**ALBANY COUNTY AIRPORT AUTHORITY
REGULAR MEETING
AGENDA
August 17, 2026**

- 11. Authorization of Change Orders**
 - 11.1 Change Order No. 22: Authorization to Award Contract Change Order #22 to Construction Contract 21-1082-GC for the Pre-TSA Terminal Expansion to MLB Construction Services, LLC**

- 11.2 Change Order No. 15: Authorization to Award Contract Change Order No. 15 to Construction Contract 21-1082-INT STR for the Pre-TSA Terminal Expansion to MLB Construction Services, LLC.**

## RFI-012 - DIAPER CHANGING STATIONS

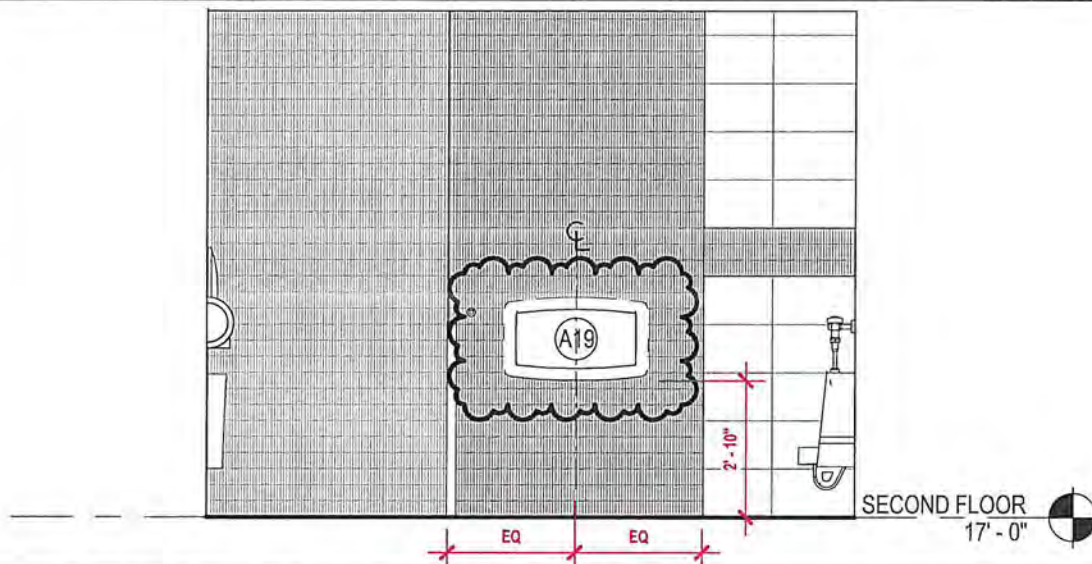
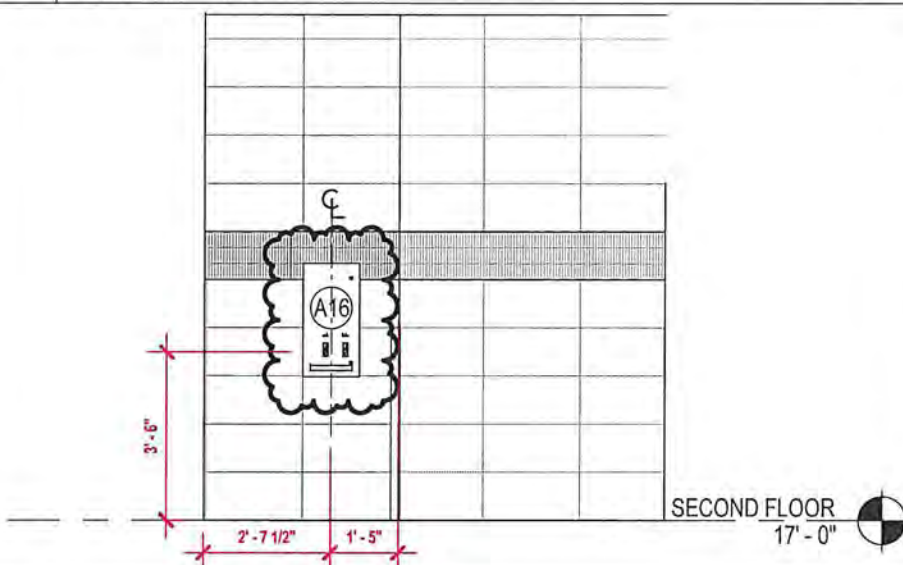
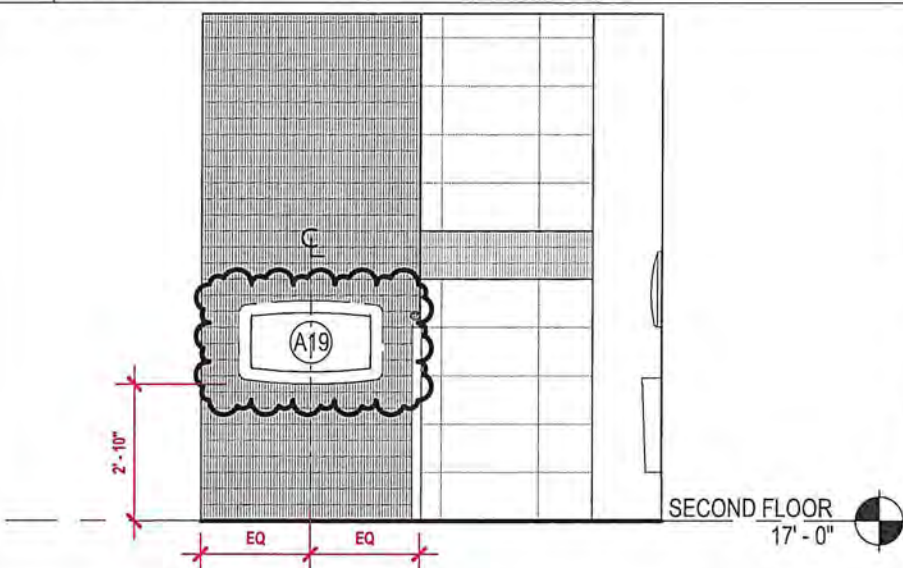
Please provide a baby changing station in both the Men's and Women's Restroom as indicated on C+S Sketch JD-3 and JD-4 dated March 24, 2026 and relocate Sanitary Product Vendor to Elevation A2. Include fire rated wood blocking as necessary.

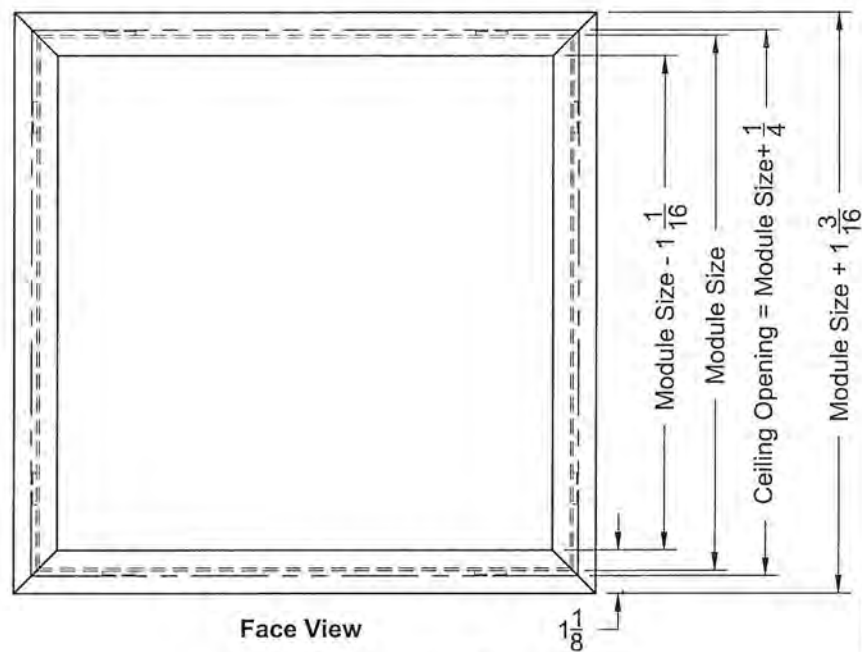
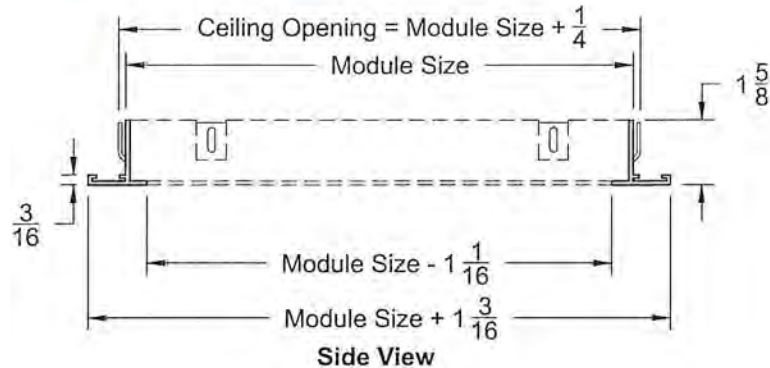
Please provide a new 2x2 return grille with a trim ring to fit into the Recompose metal panel ceiling in Room 205. Grille and trim ring shall match Project 1082-INT/STR – refer to attached approved submittal by JW Danforth.

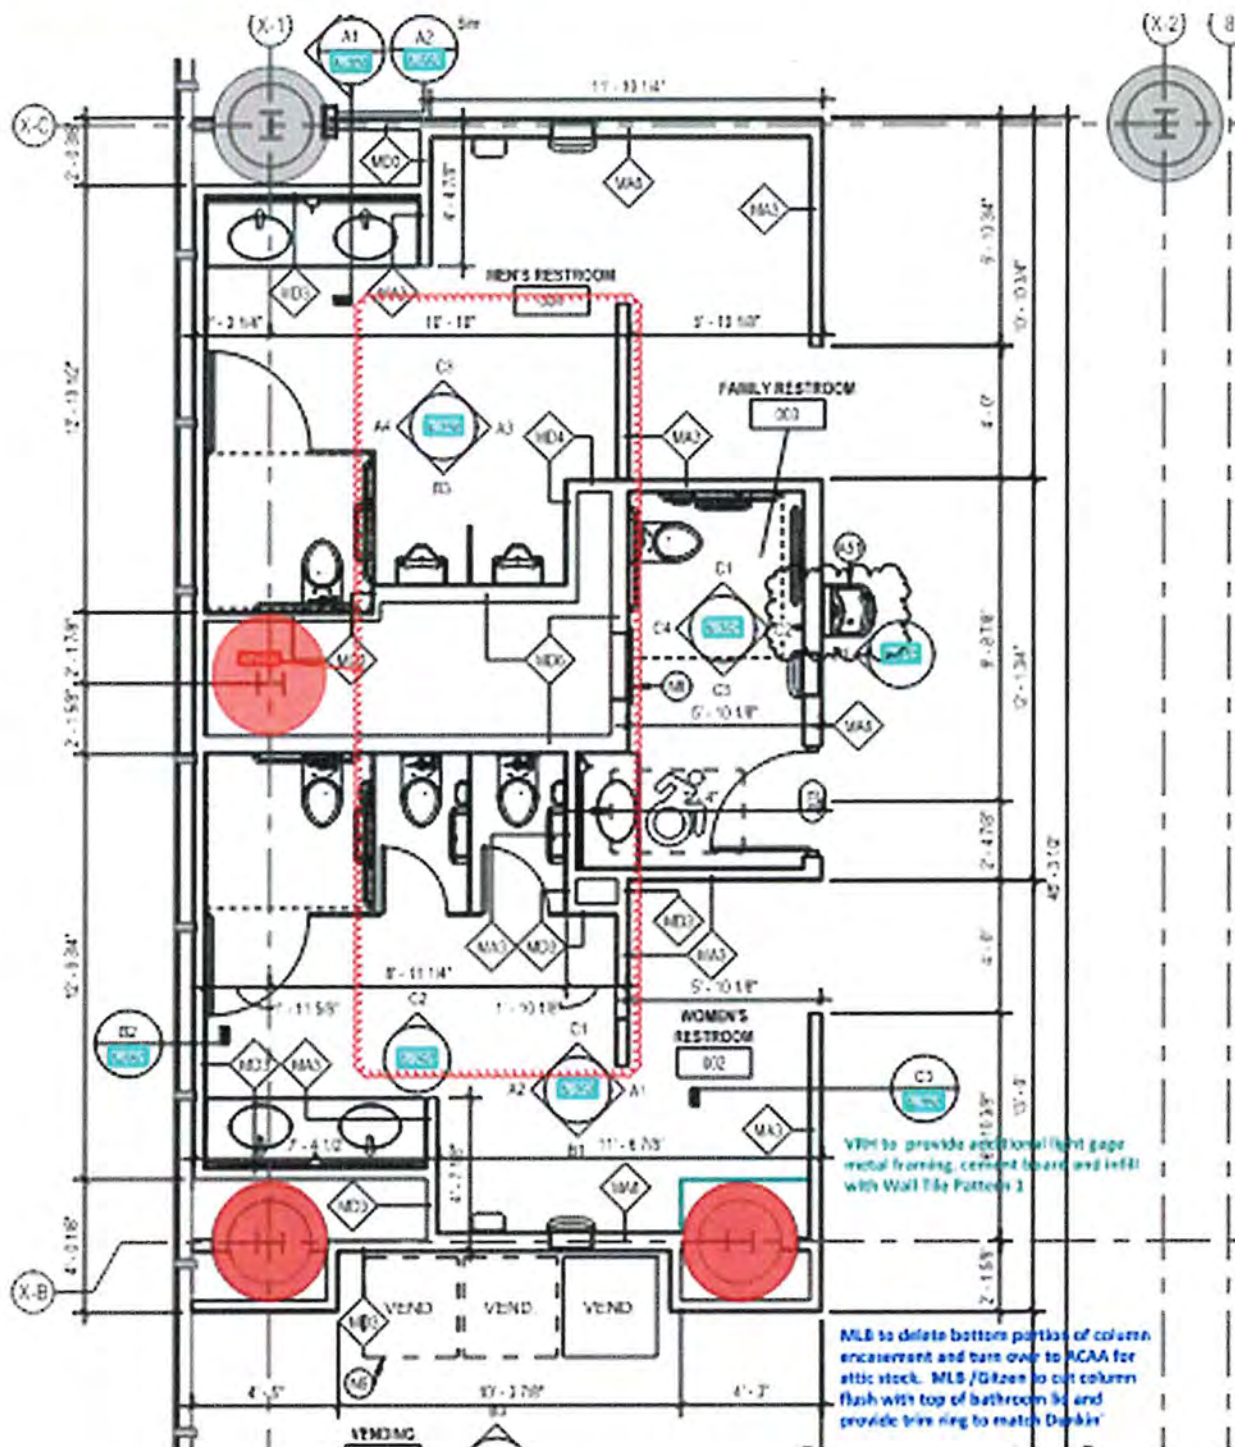
As part of the Departure Hall Project [1082-INT], MLB will delete the bottom portion of the column enclosures at Column Line X-B and X-B.5 (3 locations). MLB will modify the middle section of the column enclosure to align with the top of the ceiling lid system provided by VRH. VRH to provide additional light gage metal framing (roughly 6 lf), cement board and Wall Tile Pattern 1 in the Women's Restroom. Please provide your cost proposal within 10 business days.

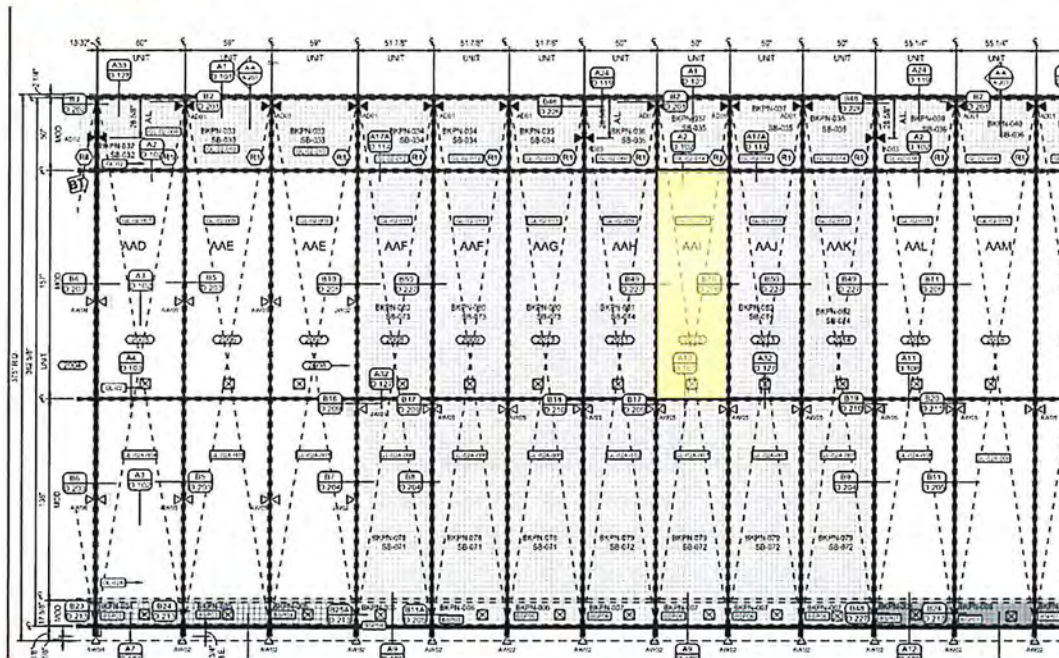
Please extend the window film approximately 9' from the previously installed window film to the end of the curtain wall in the vending area as shown below.

In addition please provide window film on the east elevation roughly 50" x 157" as shown below in lieu of the shadow box (under contract 1082-INT)
